UNITED STATES PATENT AND TRADEMARK OFFICE

APPLICATION NO.	FILING DATE	FIRST NAMED INVENTOR	ATTORNEY DOCKET NO.	CONFIRMATION NO.
10/600,503	06/20/2003	Ronald A. Klempner	AMMAR 3.0-001	5481
530	7590	06/17/2005	EXAMINER	
LERNER, DAVID, LITTENBERG, KRUMHOLZ & MENTLIK 600 SOUTH AVENUE WEST WESTFIELD, NJ 07090			ADAMS, GREGORY W	
			ART UNIT	PAPER NUMBER
			3652

Office Action Summary

DETAILED ACTION

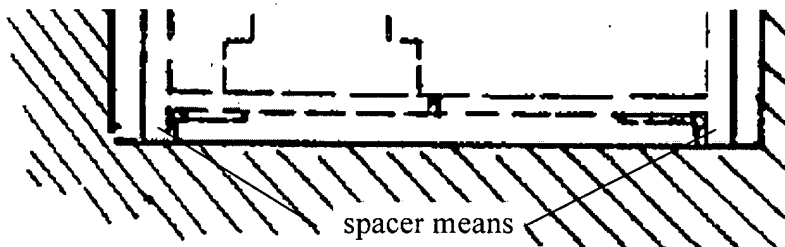
11. With respect to claim 4, Harza discloses a wall means 164 comprising spacer means as shown in FIG. 7 below.
